## SERVICE INFORMATION NO. SI 42-087

GARMIN – Service Bulletin No. 0823 Rev. B  
ATA-Code: 34-00

**NO.: 0823 Rev B**

**SUBJECT:** GDU 104X CRS/BARO Knob Interference

**Figure 1**

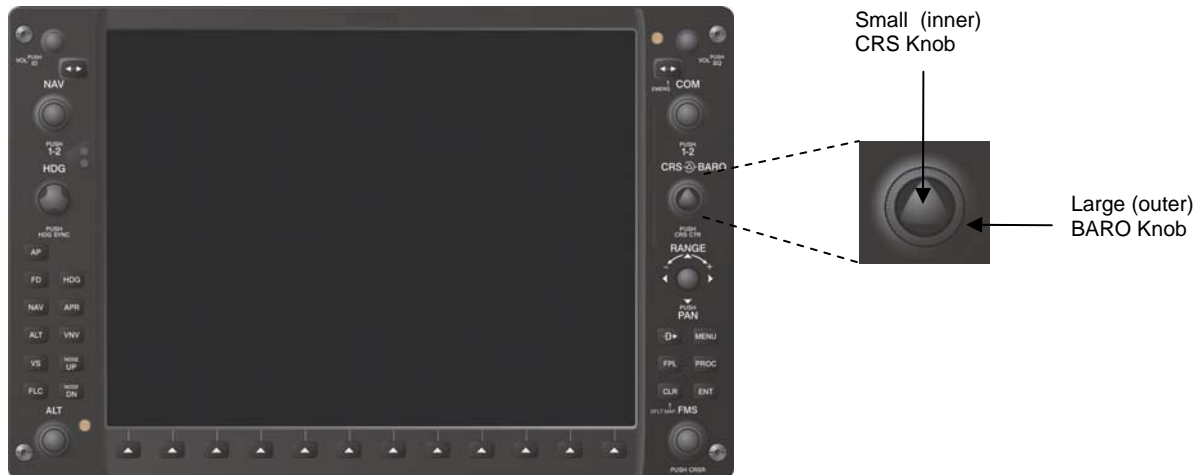
Garmin has identified an issue, whereby the large (outer) BARO knob and the small (inner) CRS knob may interfere with each other.

This service bulletin contains instructions on how to test for knob interference and remove/replace the CRS/BARO knobs, as required.

**Figure 4**

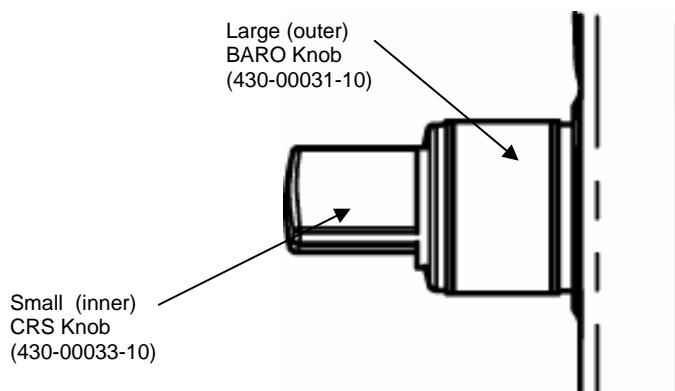
If CRS/BARO Knob interference is confirmed, perform the steps below to replace the CRS/BARO Knob. New knobs can be obtained through a Garmin Service Center or Aircraft OEM under Garmin part number K00-00446-00.

5. Grasp the large (outer) BARO knob (insuring proper orientation) and place it over the shaft.
6. Align the flat side of the knob insert with the flat side of the shaft.
7. Press down firmly to ensure knob is completely seated, refer to Figure 4.
8. Grasp the small (inner) CRS knob (insuring proper orientation) and place it over the shaft.
9. Align the flat side of the knob insert with the flat side of the shaft.
10. Press down firmly to ensure knob is completely seated, refer to Figure 4.
11. Perform the CRS/BARO Knob Interference Test (contained in the TESTING PROCEDURE section) again to confirm there is no interference.
12. Accomplish aircraft logbook entry to return aircraft to service in compliance with this service bulletin.
